# CITY OF PORTLAND BUILDING PERMIT

**PERMIT ID:** 2013-00093

has permission to **Build a 18' x24' attached, two story garage w/ living space above** provided that the person or persons, firm or corporation accepting this permit shall comply with all of the provisions of the Statutes of Maine and of the Ordinances of the City of Portland regulating the construction, maintenance and use of the buildings and structures, and of the application on file in the department.

Proposed Use: Single Family Home	Proposed Project Description: Build a 18' x24' attached, two story garage w/ living space above
-------------------------------------	--

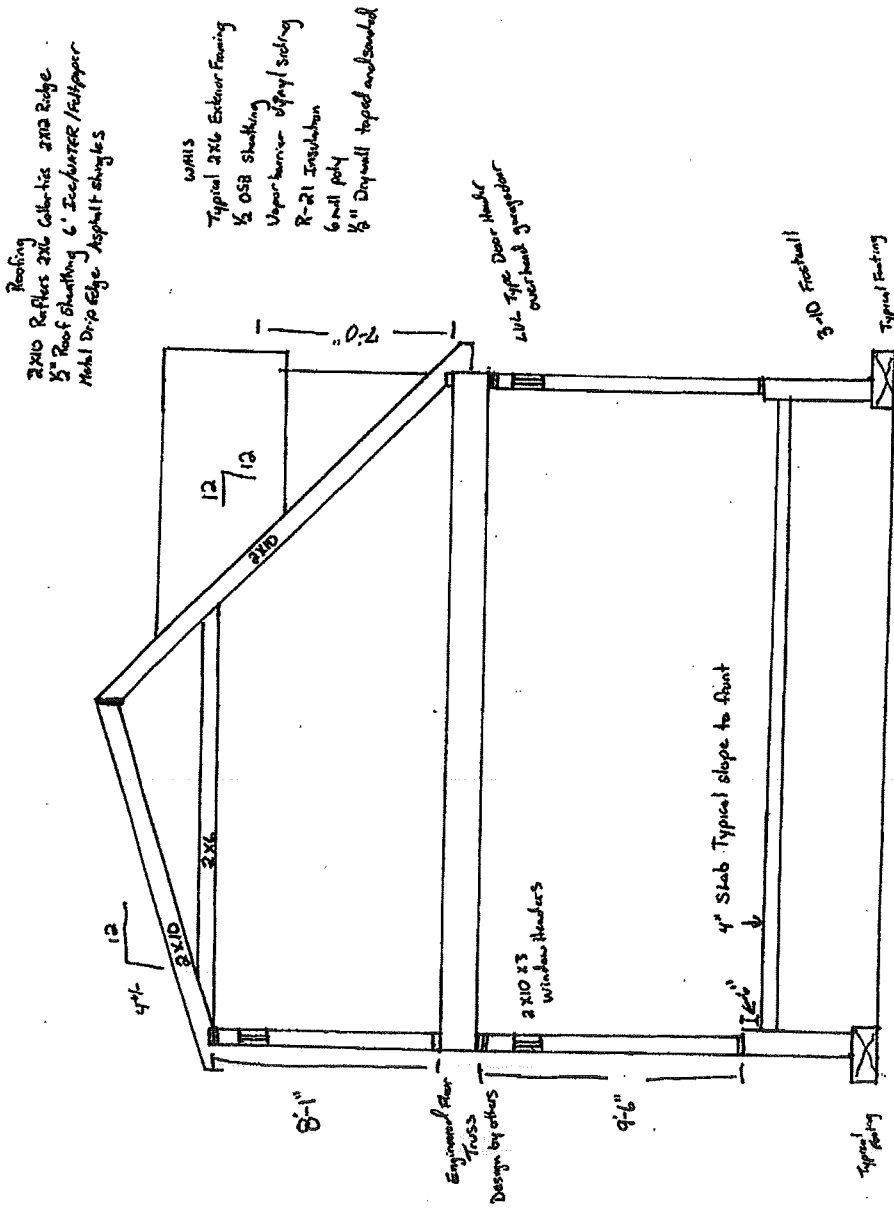
At your request I have reviewed the W14x38 steel beam being proposed to clear span the basement area for a residence being constructed at 64 Gertrude. The work provided by M<sup>2</sup> Structural Engineering was limited to the review of the steel beam only.

Based on this review we have found that the proposed W14x38 steel beam is capable of spanning the proposed 23'-6" to clear span the basement.

Adequate support at both end of this beam is required. The design of the supports and connection details will be by others. These supports should be designed for a minimum load of 15,600 pounds at each end. If a steel lally column is used to support the end of the steel beam, proof of the allowable load capacity of the lally column should be submitted.

**CROSS SECTION B-B**

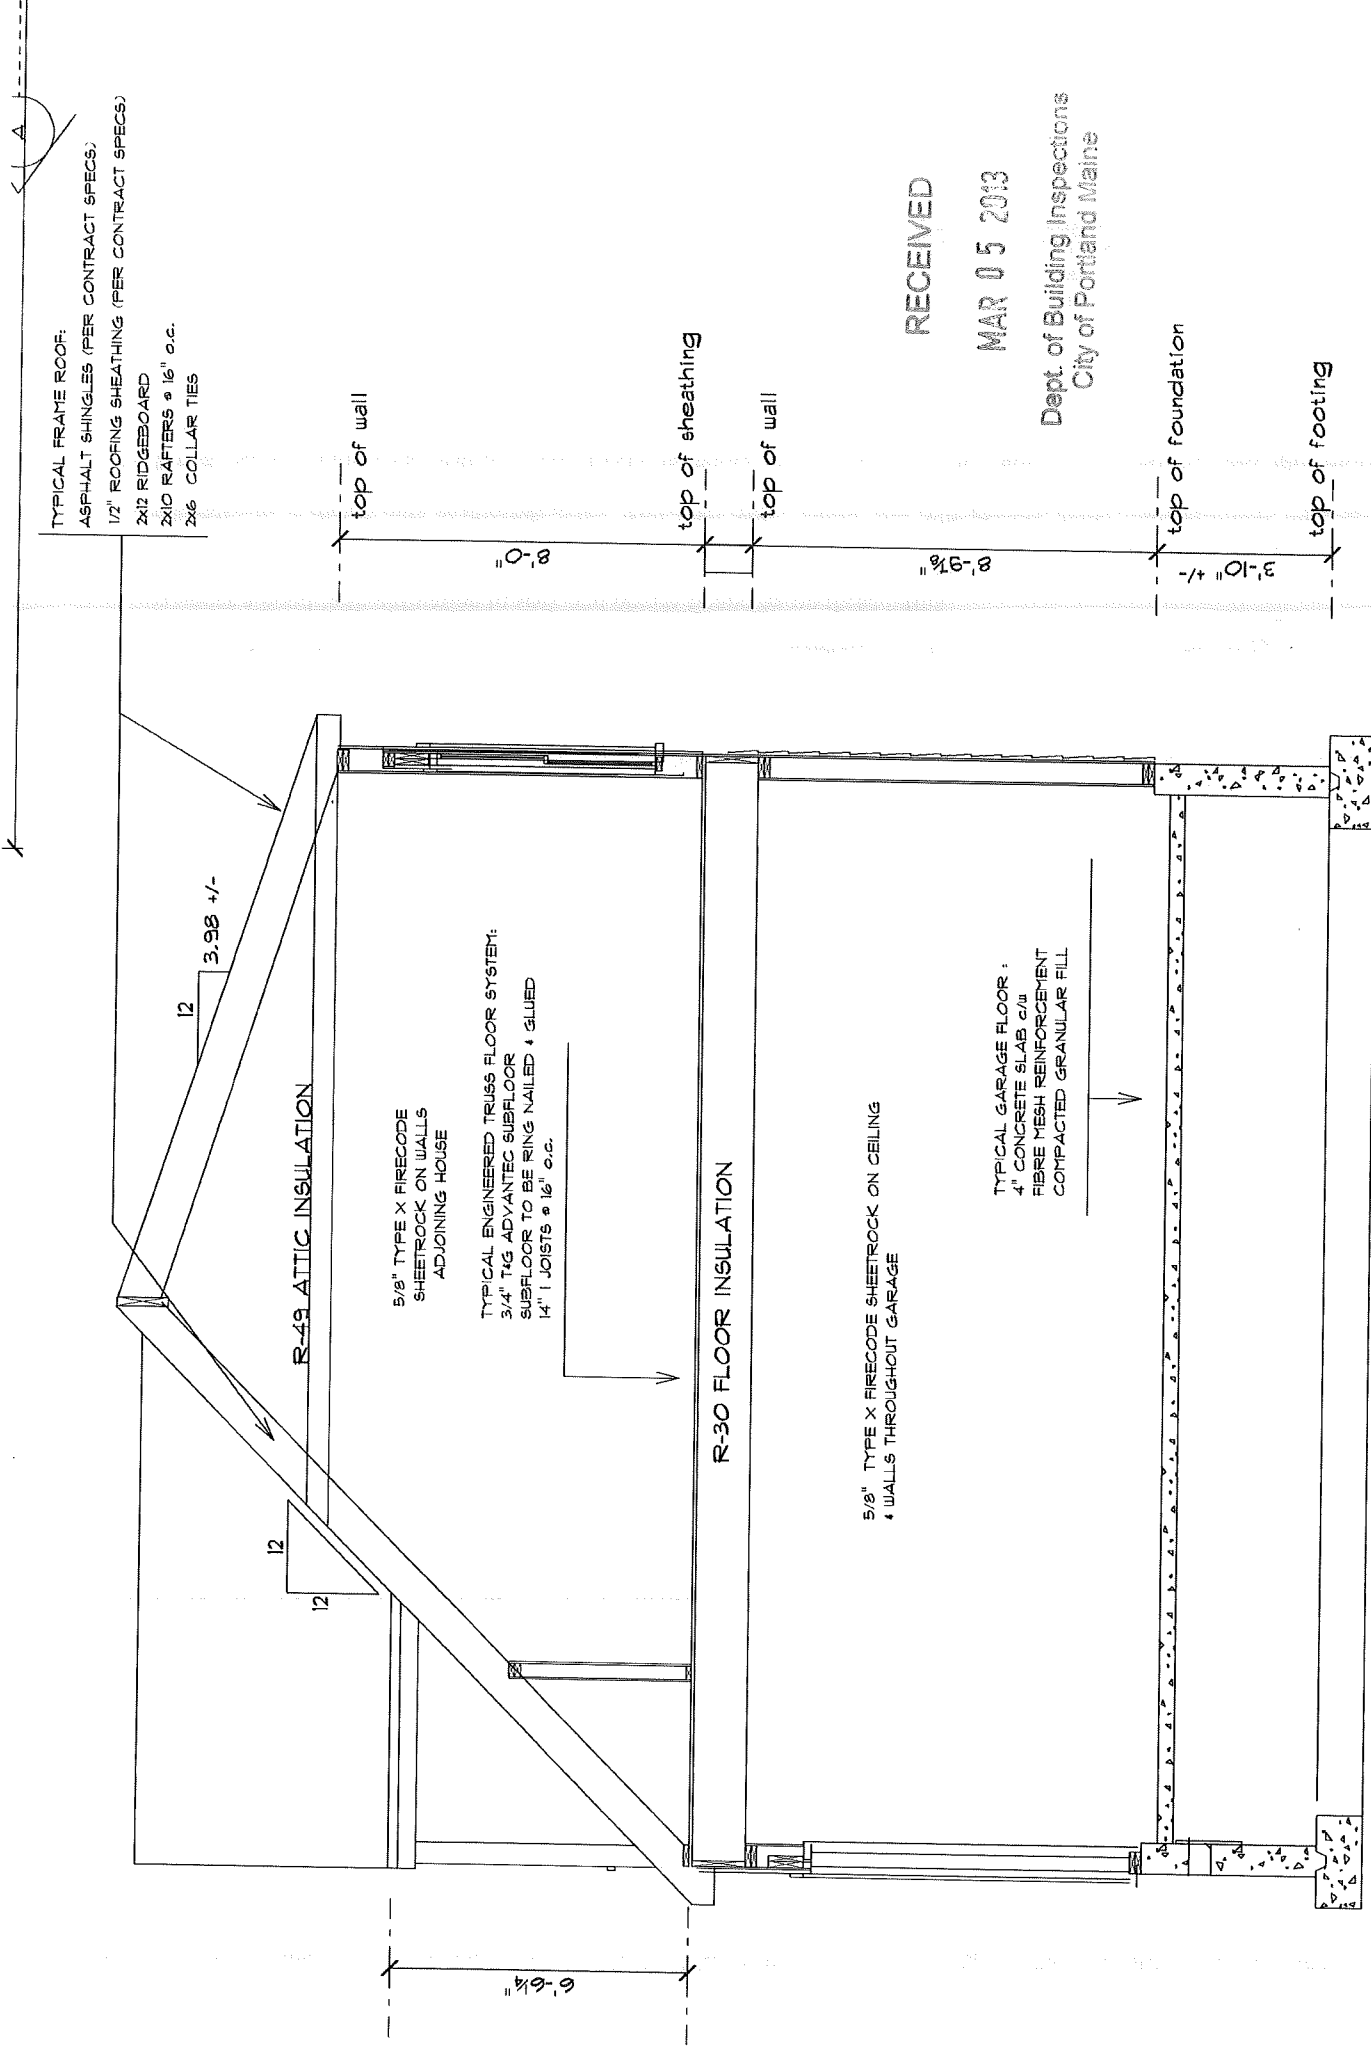
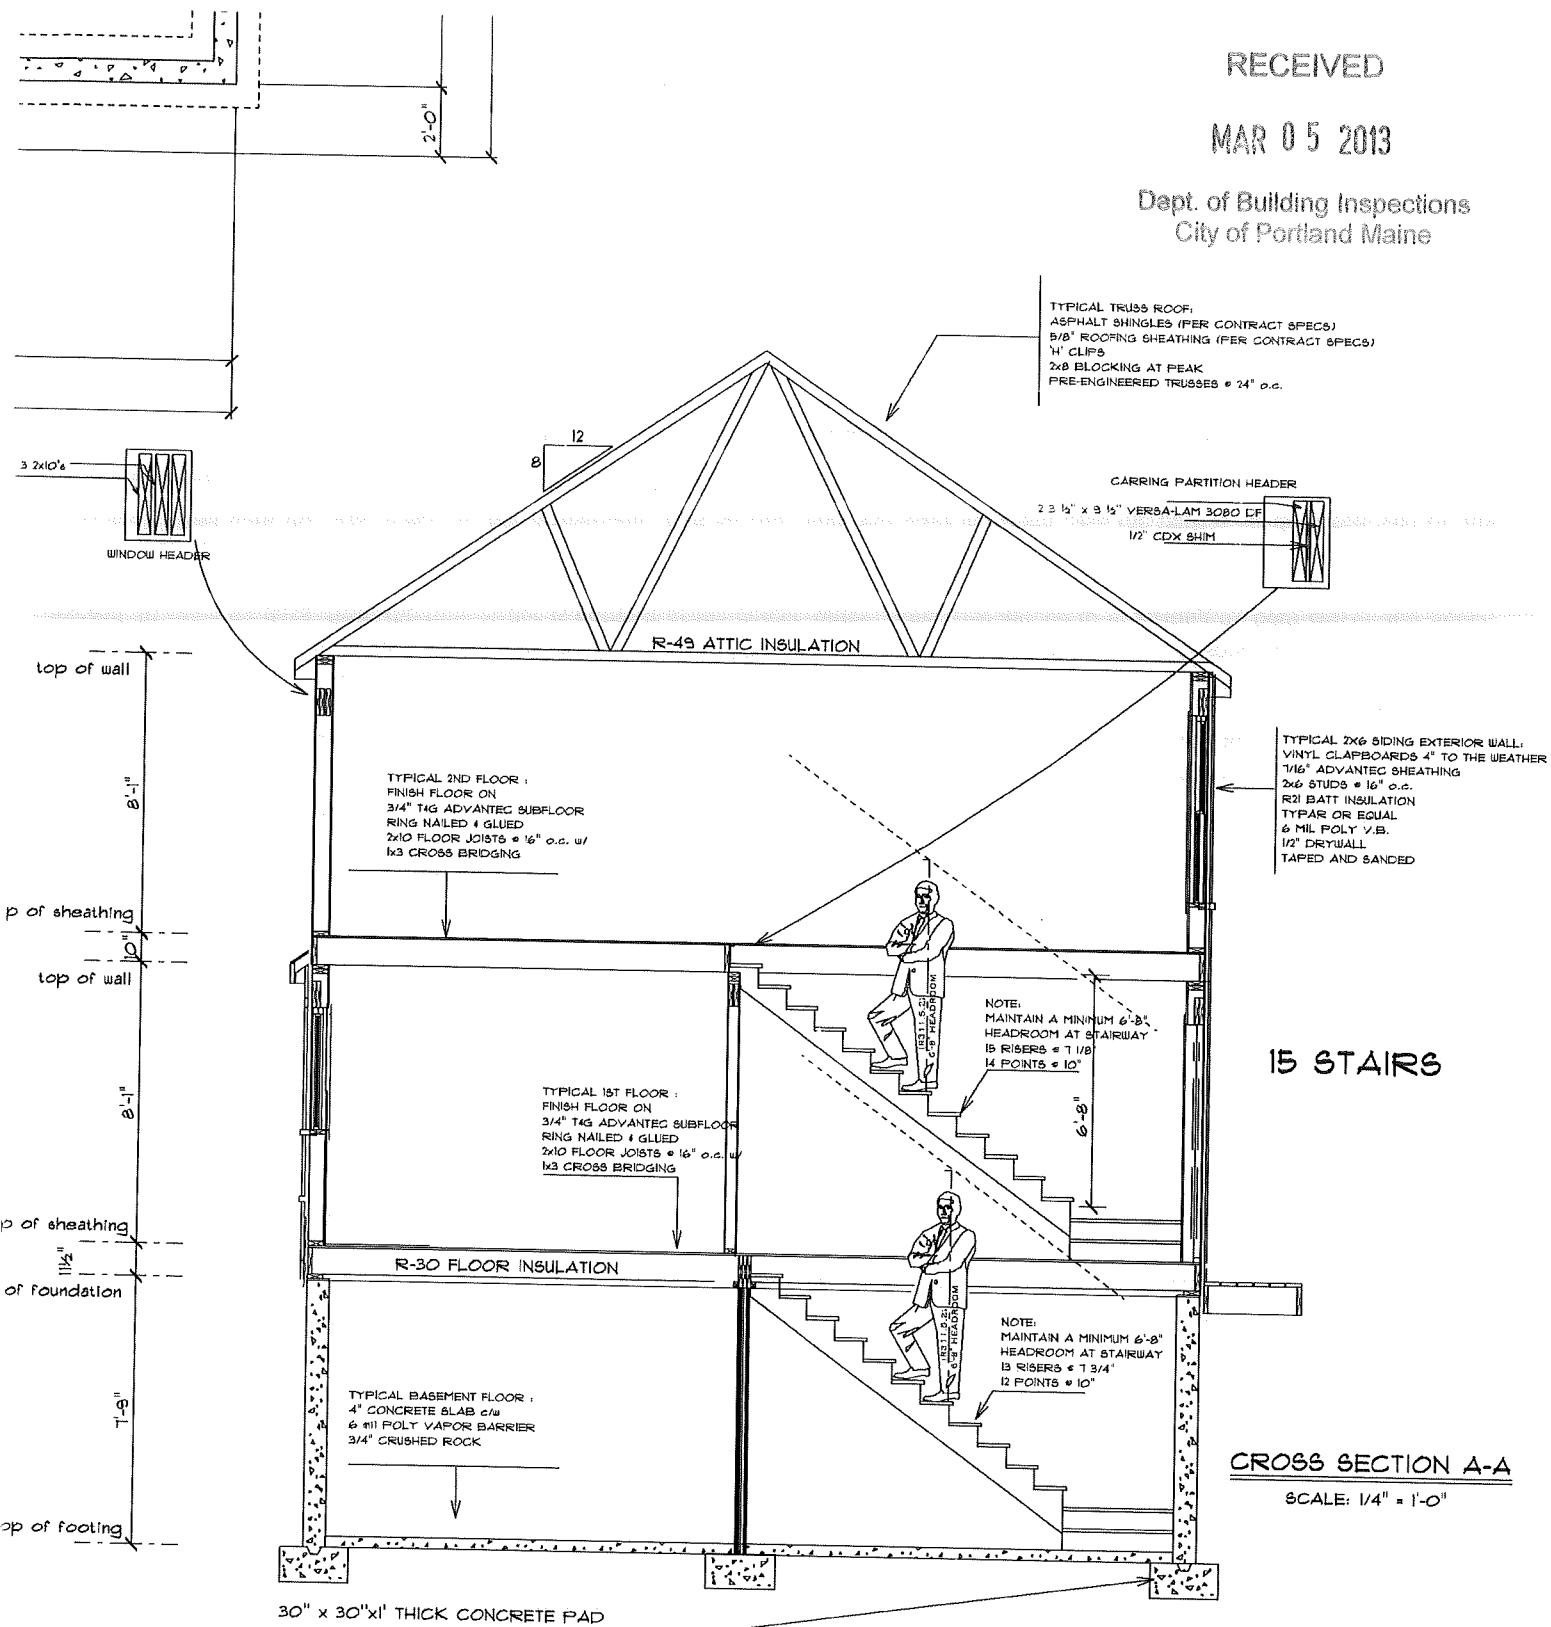
What about the door detail from the basement to the exterior? Are the roof rafters 16 inches on center and what is the headroom in the bathroom section at least 6'-8" in front of each fixture? Are you applying 1/2" Gypsum to the walls, and 5/8" Type X gypsum to the ceiling of the garage, underneath the habitable space?

Door detail attached. Rafter spacing indicated at 16' OC, Headroom noted as minimum 6'8" but not on plan. All living space below/abutting garage is fire rated sheetrock minimum with minimum 5/8 TYPE X Gypsum and other walls noted as 1/2" Gypsum. I want to dig in the morning. Is this satisfactory? Let me know if you need additional data. I apologize I forgot about the doors/stairway.
